December 30, 2004

Re: The Department of Ecology Decision on Further Investigations at the Landsburg Mine site, Ravensdale

Summary and Recommendations on Issues of Additional Investigation at the Landsburg Mine site in Ravensdale

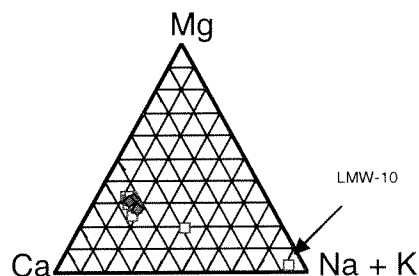
- 2) The well or wells may serve as early warning or sentinel well(s) in the possible event of a release from the source area in the trench. For example, in the event of an earthquake, the buried drums may potentially shift and rupture. Therefore, the deep well(s) may be monitored for contaminants to track contaminant transport.
- 3) The well(s) may be used for remediation or to extract mine water, thus lowering the water table and providing inward hydraulic gradients that will prevent breakout of potentially contaminated mine water.
- 4) There is evidence that deeper groundwater at the site is geochemically different from shallow groundwater based on major cation compositions. For example, the deep northern well LMW-10 that is screened at an elevation of 338.5 feet above sea level is richer in the alkalis Na + K and lower in Ca and Mg compared to other waters:

Data for the above graph was taken from the May 2004 groundwater analytical results. LMW-10 was a recently installed deep well. At present, we cannot preclude the high Na and K to be artifacts of the well installation process (from bentonite seal or from material in Portland cement used to fill the borehole beneath the well screen). Coupled with an upward hydraulic gradient at the discharge (portal) areas, this points to a complex flow system with upward groundwater flow from deeper levels. If there is contaminated water at these deep levels, based on the results of LMW-10, it may be expected that deeper waters may reach the shallow levels that affect groundwater use and surface water quality. Therefore, there is a need to identify the water quality emanating from the deeper region of the former mine.

Figure 1

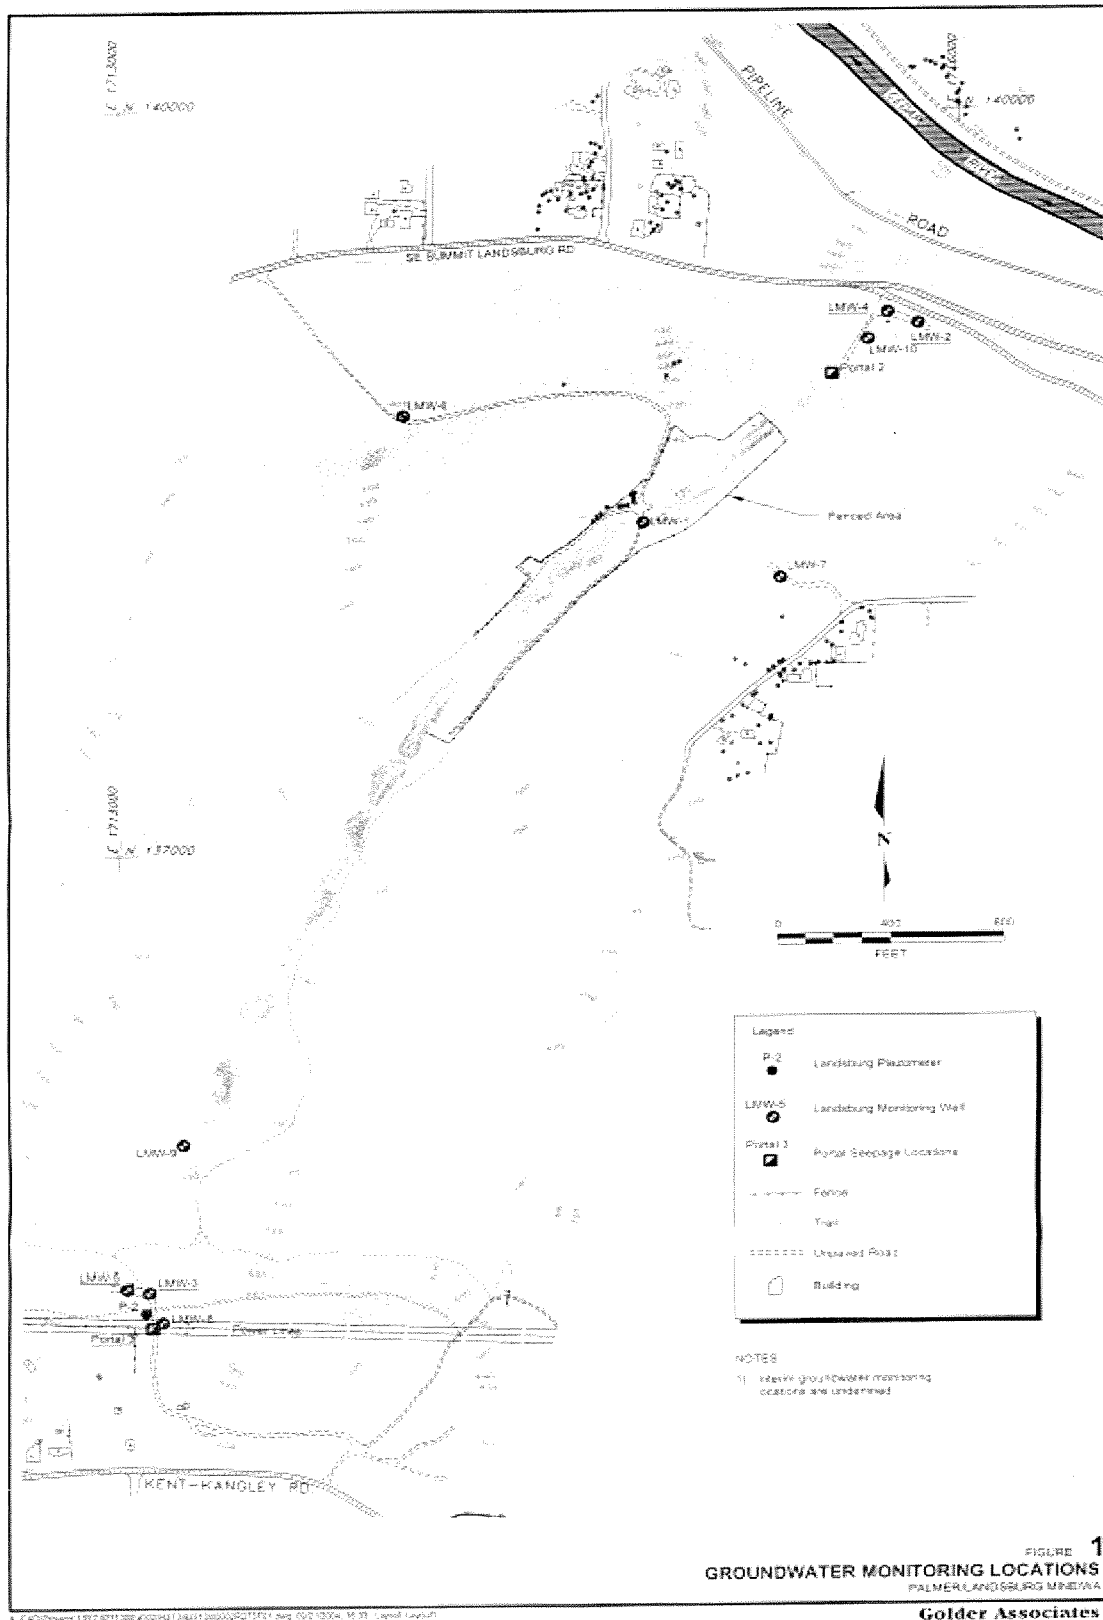
May 2000: Wells sampled were LMW-2, LMW-4, LMW-3, LMW-5, and Rogers Portal #3 seep water (see Figure 1 map). Results showed no significant change from 1996 Report of Investigation. Total dissolved solids, iron and manganese were the only compounds detected in excess of screening levels which are secondary maximum contaminant levels (SCMLs). SCMLs are not health based standards, but are based on aesthetic qualities of water. The high iron and manganese concentrations appear to be typical of coal mining regions.
